ECN/PCN No.: 3448

For Manufacturer			
<b>Product Description:</b> 32.768kHz SMD Crystal		<b>Abracon Part Number / Part Series:</b> ABS13	
<b>Affected Revision:</b> K		<b>New Revision:</b> L	
		<b>Application</b>	
		<input checked="" type="checkbox"/> Series <input type="checkbox"/> Part Number <input type="checkbox"/> Safety <input checked="" type="checkbox"/> Non-Safety

**Prior to Change:**

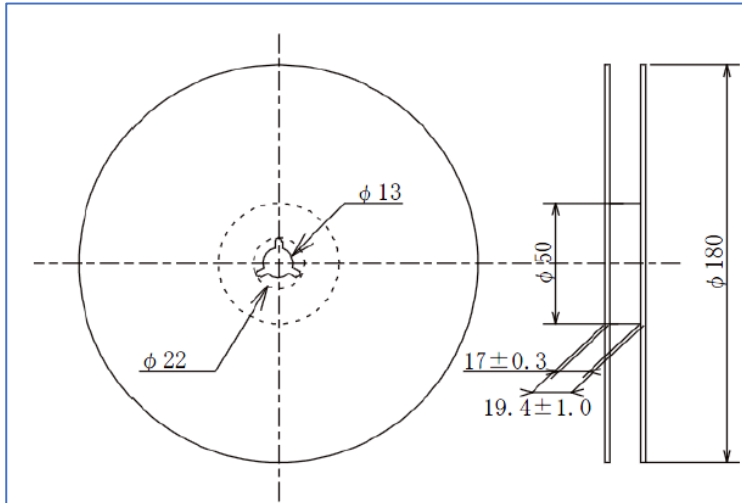
1. ROHS Statement
  - a. RoHS/Ro HS II compliant. Pb in high temperature solder (exempt 7(a) per RoHS II 2011/65/EU Annex)
2. Electrical performance
  - a. Frequency Coefficient ( $\beta$ ):
    - i. Min =  $-0.040 \text{ ppm/T}^2$
    - ii. Typ =  $-0.034 \text{ ppm/T}^2$
    - iii. Max =  $-0.028 \text{ ppm/T}^2$
3. Mechanical Dimensions (millimeters)
  - a. Side view; height dimension =  $1.3 \pm 0.1 \text{ mm MAX}$
  - b. Side view; lead/pad height dimension =  $0.15 \text{ mm}$
  - c. Bottom view; lead/pad width dimension =  $0.3 \text{ mm}$
  - d. Bottom view; lead/pad length dimension =  $0.4 \text{ mm}$
  - e. Bottom view; length between pad #2 & #3 =  $0.55 \text{ mm}$

4. Reel Packaging Dimensions (millimeters)
  - a. Top view; inner radial dimension = 13
  - b. Side view; outer radial dimension =  $\varnothing$  180
  - c. Side view; inner radial dimension =  $\varnothing$  50
  - d. Side view; outer height dimension =  $19.4 \pm 1.0$  mm
  - e. Side view; inner height dimension =  $17 \pm 0.3$  mm

**After Change:**

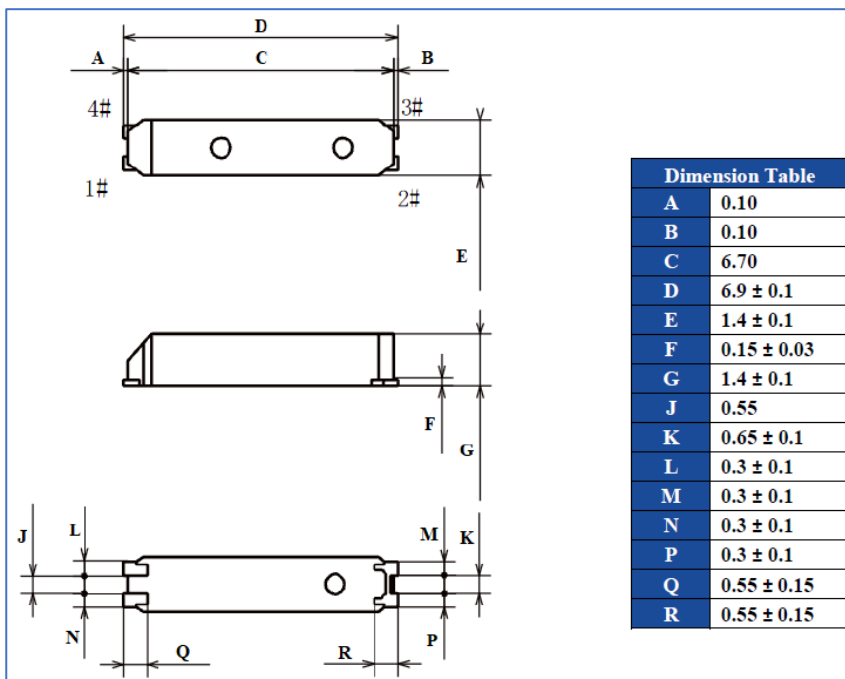
1. ROHS Statement
  - a. RoHS/RoHS II compliant. Pb in high temperature solder (exempt 7(a) per 2015/863/EU Annex)
2. Electrical performance
  - a. Frequency Coefficient ( $\beta$ ):
    - i. Typ =  $-0.035 \pm 0.01$  ppm/ $^{\circ}$ C<sup>2</sup>
3. Mechanical Dimensions (millimeters)
  - a. Side view; height dimension =  $1.4 \pm 0.1$  mm MAX (increase)
  - b. Side view; lead/pad height dimension =  $0.15 \pm 0.03$  mm (increase)
  - c. Bottom view; lead/pad width dimension =  $0.3 \pm 0.1$  mm (increase)
  - d. Bottom view; lead/pad length dimension =  $0.55 \pm 0.15$  mm (increase)
  - e. Bottom view; length between pad #2 & #3 =  $0.65 \pm 0.1$  mm (increase)

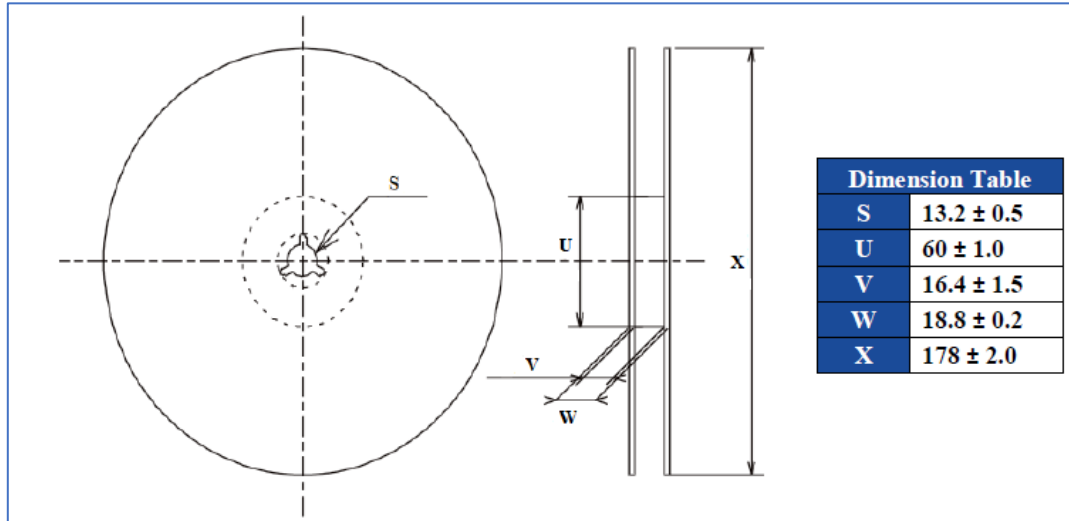
4. Reel Packaging Dimensions (millimeters)
- Top view; inner radial dimension =  $13.2 \pm 0.5$
  - Side view; outer radial dimension =  $\varnothing 178 \pm 2.0$
  - Side view; inner radial dimension =  $\varnothing 60 \pm 1.0$
  - Side view; outer height dimension =  $18.8 \pm 0.2$  mm
  - Side view; inner height dimension =  $16.4 \pm 1.5$ mm
